**MEMORANDUM**

**REVIEW TYPE:** Preliminary Plan of Subdivision

**PROJECT NAME:** Damascus Smart-Miner

**CASE #:** 120070340

**PRELIMINARY PLAN OF SUBDIVISION**  
1000 L. ...  
1000 L. ...  
1000 L. ...

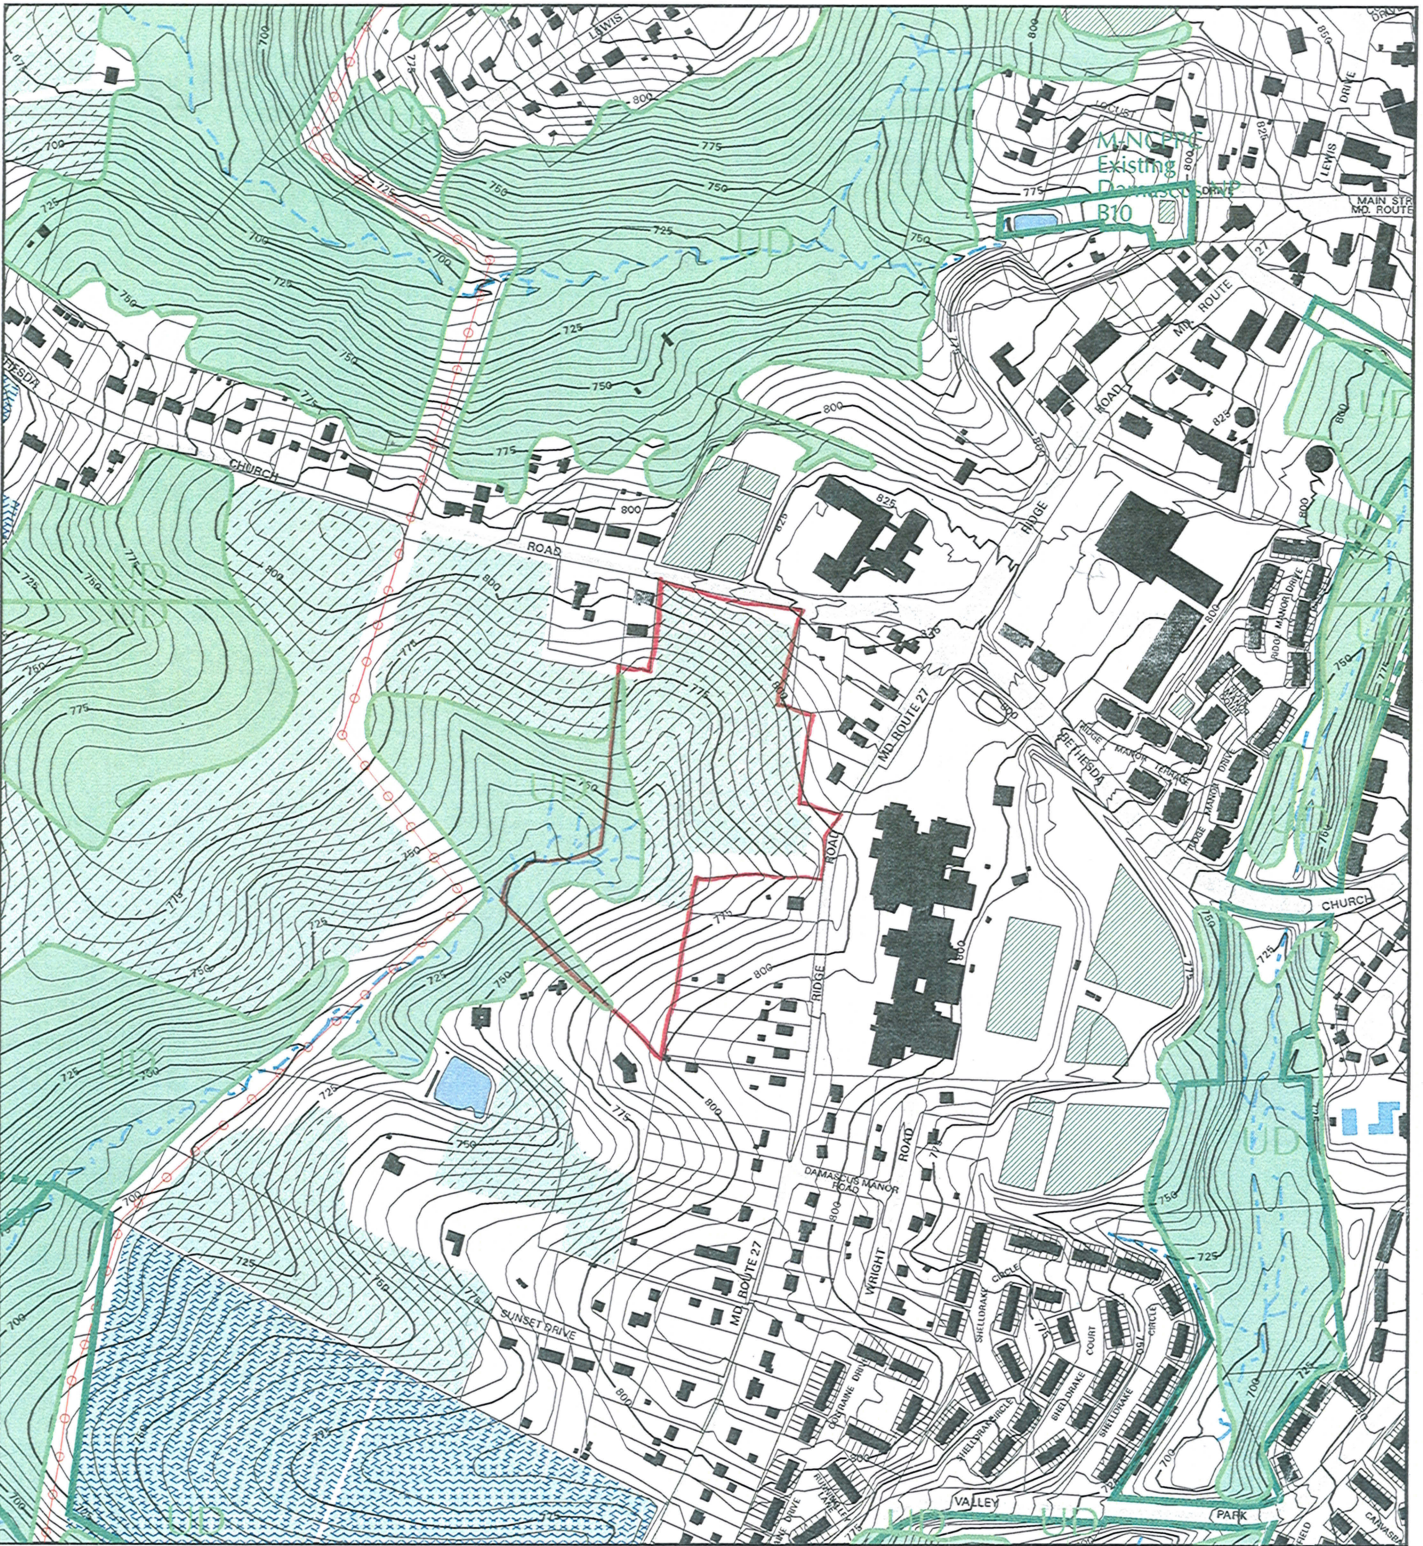
- 4) Prior to certification of the preliminary plan, the applicant must amend the data table on the plan to correctly show the minimum lot area and minimum rural open space area proposed by the preliminary plan.
